## ADDENDUM #3

PROJECT NAME:	Doyle Thomas Park Splashpad
PROJECT # (CITY):	IFB-22-23-046
PROJECT # (SITE COLLAB):	19100.03
ADDENDUM ISSUE DATE:	December 12, 2022
ISSUED BY:	Graham H. Smith, PLA @ Site Collaborative and Carol Henley, Acting Director of Purchasing @ City of Danville

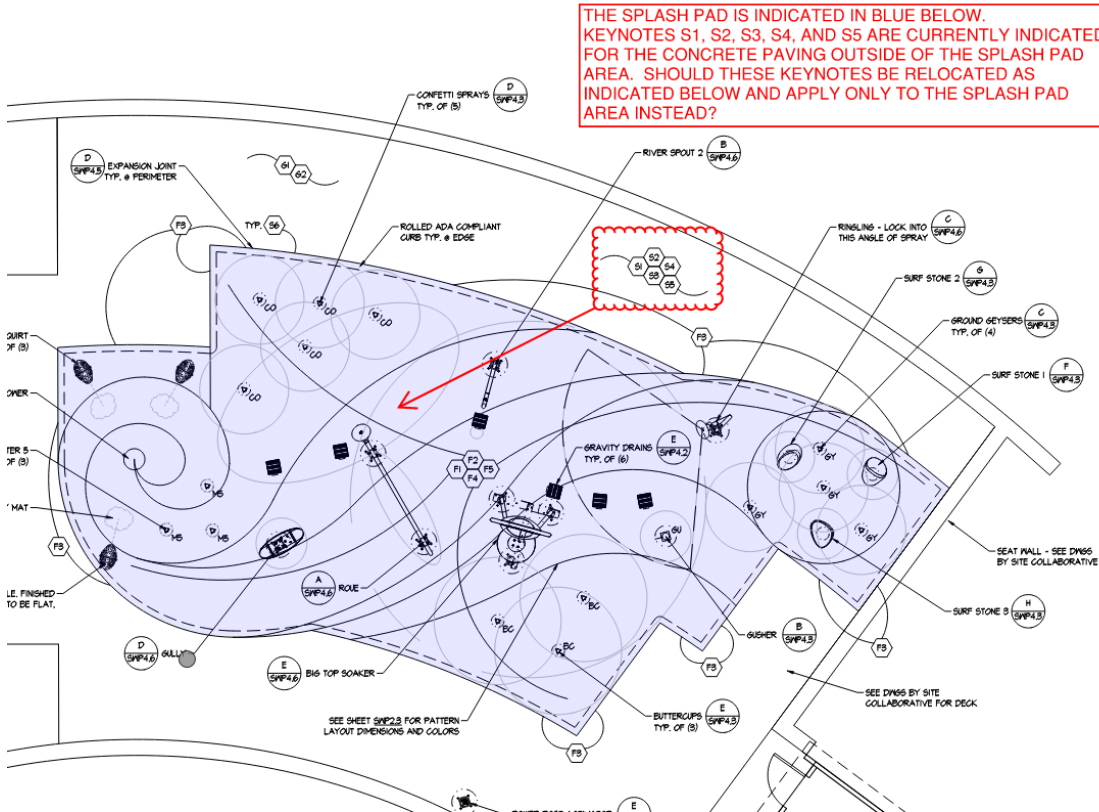
Q1: See Image Below for Question:

*RESPONSE: Those notes are typical for the Splashpad area as a whole as needed, but yes specifically for the Splashpad area. They are shown on the sheet as a general callout and are only referencing the splashpad.*
